City of Central Point, Oregon

RE: CP Senior Living Site Plan and Architectural Review (File No. 16032)

STAFF REPORT
January 24, 2017

ITEM (File No. 16032)

SHEET TITLE
**SITE CONTROL
& KEY PLAN**

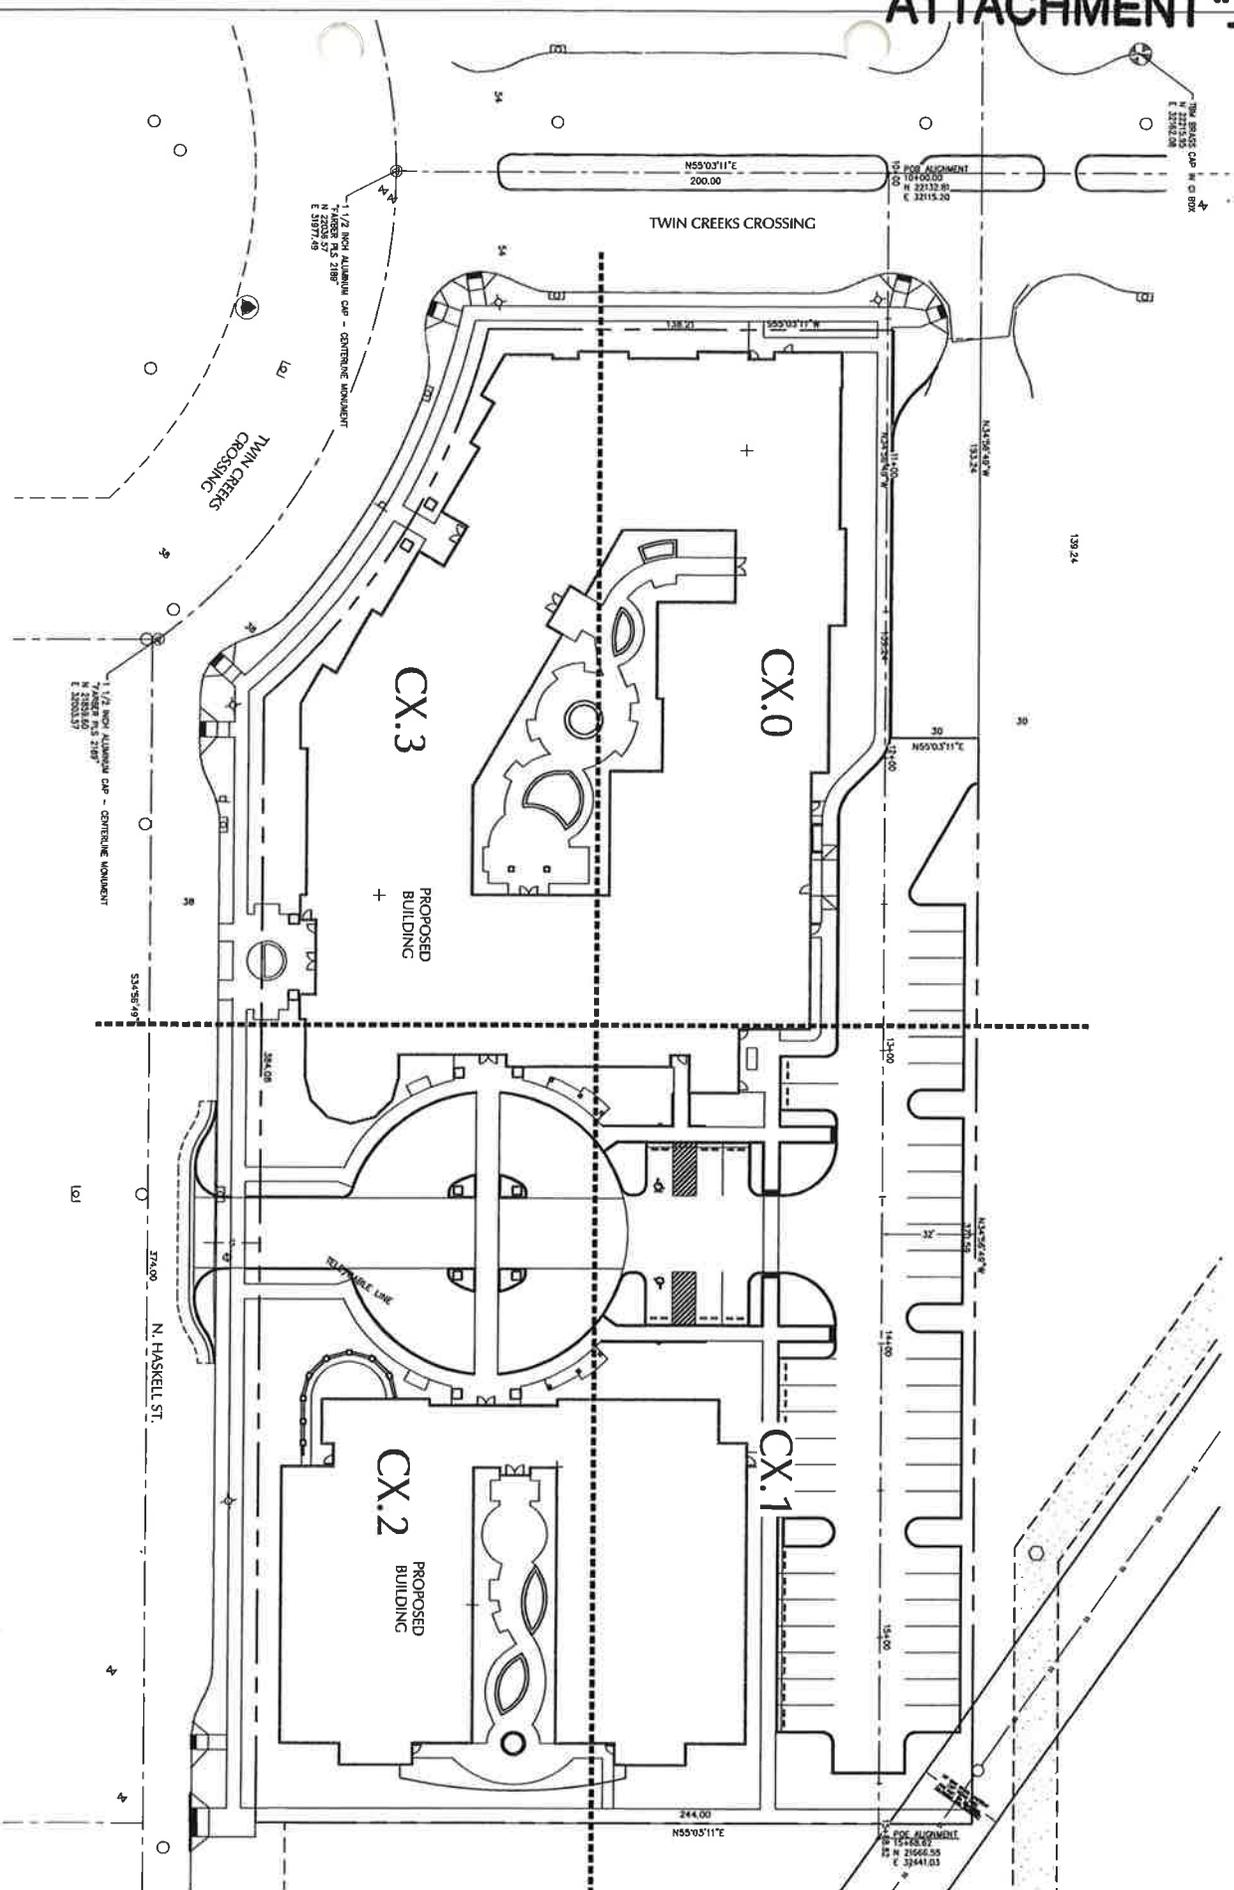
proposed site plan (Attachment "A-2") it was proposed that the primary through access route was to occur on the adjacent easterly property (37S 2W 03CA Tax Lot 1500), continuing south to be used by the adjacent southerly property (37S 2W 03C Tax Lot 138). With the exception of a transitional area immediately south of where Boulder Ridge Street ends no shared access was needed from the Applicant's site. The shared access illustrated on the Applicant's site plan is generally considered sufficient for its intended purpose (north/south circulation), but does not address the need for shared access on either the Applicant's site or the abutting sites. For purposes of clarification Staff has prepared Attachment "C" illustrating minor modifications to the proposed shared access that addresses minimum lane standards and existing property lines..

ATTACHMENT "C"

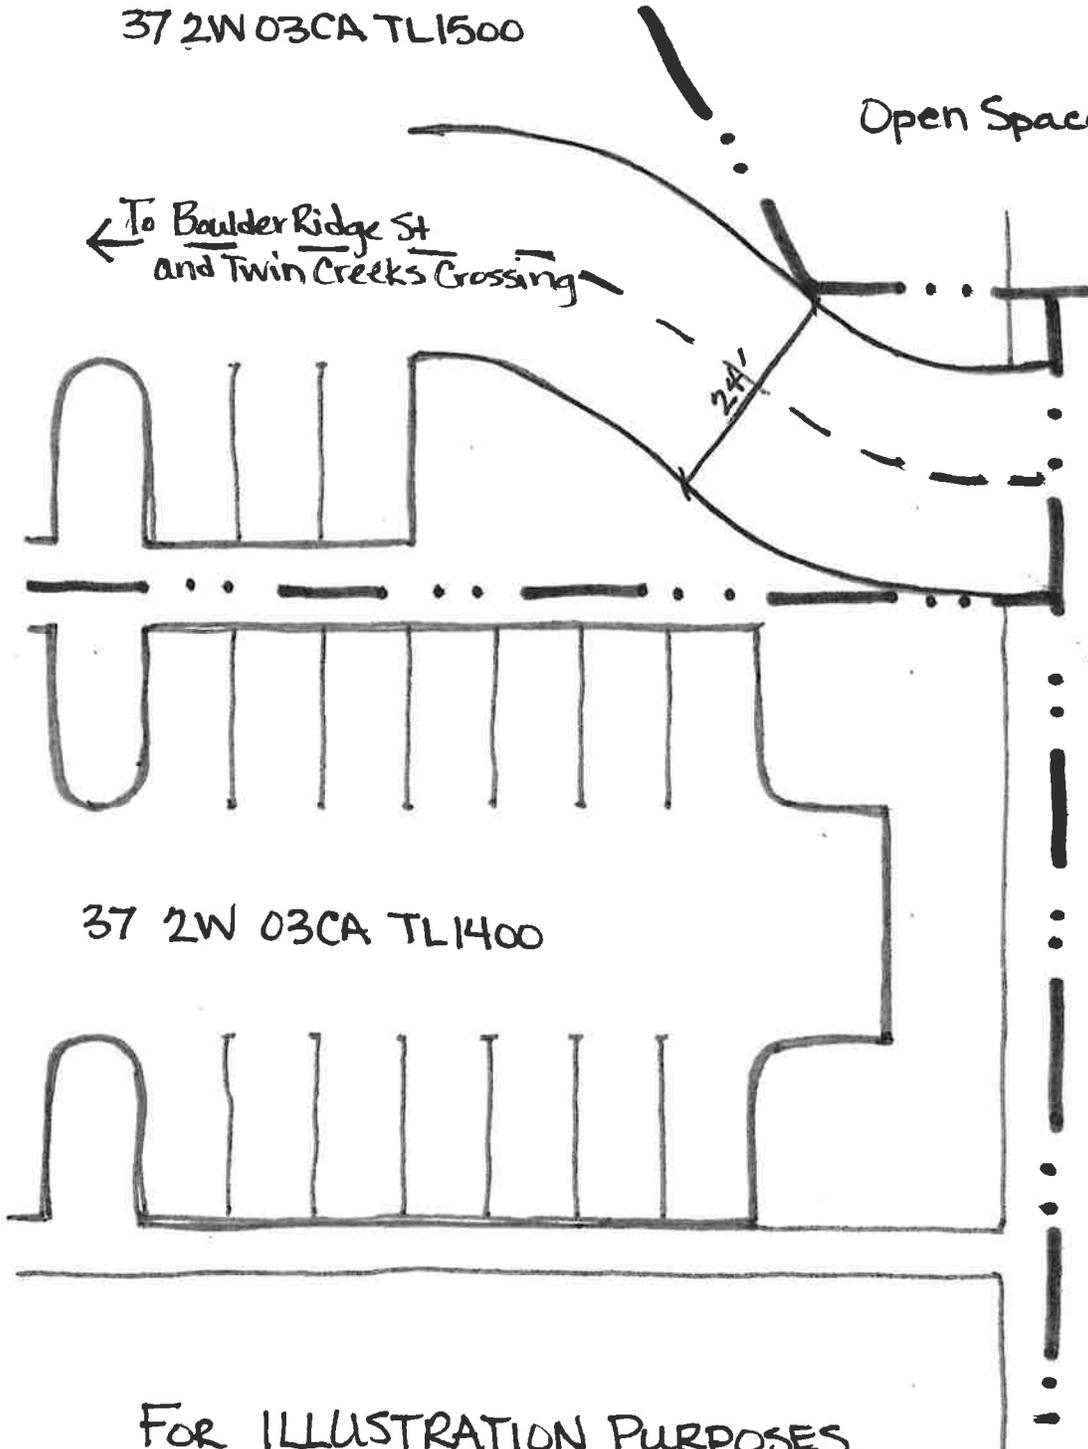
Comment: As illustrated in Attachment "C", there is sufficient area east of the project site to construct a 24-ft shared access drive between the property to the east (37S 2W 03CA Tax Lot 1500) and the property to the south (37S 2W 03C Tax Lot 138) ("Properties"). As shown, shared access can be accommodated without impacting the Applicant's site plan. Staff recommends that Attachment "C" is sufficient to demonstrate shared access necessary for future development of the "Properties". Unless access from Boulder Ridge Drive is modified (move the divider island northerly) a reciprocal access agreement with the property to the east will be necessary to assure shared access near the Boulder Ridge Street right-of-way (Condition No. 1).

1. Prior to building permit issuance, the Applicant shall provide signed and recorded reciprocal access easement with the adjoining parcel to the east (37S 2W 03CA Tax Lot 1500) as necessary to access the site via Boulder Ridge Street. This condition may be waived if the Applicant adjusts the location of the dividing island to eliminate the need for a shared access agreement.
